# Technical Review

<b>To:</b>	Shay McDonald	<b>Date:</b>	20 March, 2026
<b>Authority:</b>	Otago Regional Council	<b>Ref:</b>	25080A3.0
<b>Consent:</b>	Fast-Track Bendigo Ophir Mine		
<b>From</b>	<b>Role in Audit</b>		
Alexandra Badenhop	Surface water modelling, Groundwater & Geochemistry

Matakanui Gold Limited (the applicant) is seeking fast-track approval for the Bendigo-Ophir Gold Project. The Otago Regional Council (ORC) has asked me to undertake a technical review of the groundwater, geochemistry and surface water modelling components of their substantive application.

Source: Figure 9, KSL (2026)

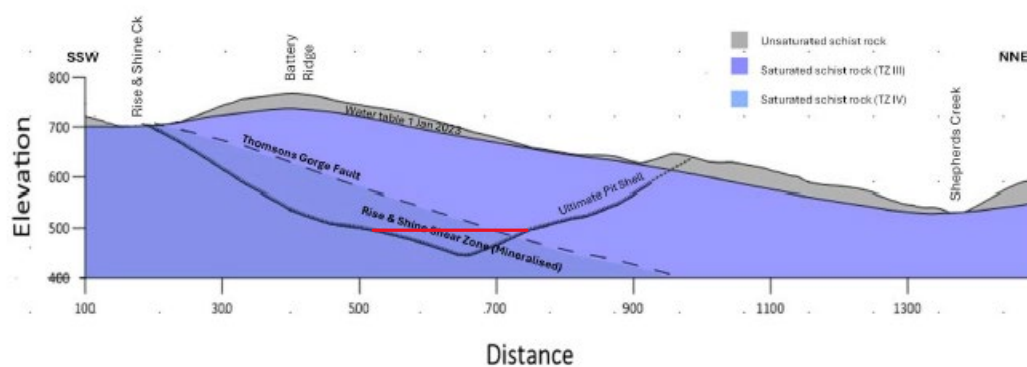
Monitoring of groundwater levels is proposed around the RAS pit to assess the propagation of the drawdown cone and potential to impact Rise and Shine Creek and associated wetlands. Note that the water table will be permanently changed from the pre-development water table with the RAS pit lake level modelled to stabilise at 490 mASL (red line superimposed on provided figure). It is unclear what level the groundwater table will stabilise to after closure, however it is expected that groundwater gradients, and hence flows will change permanently.
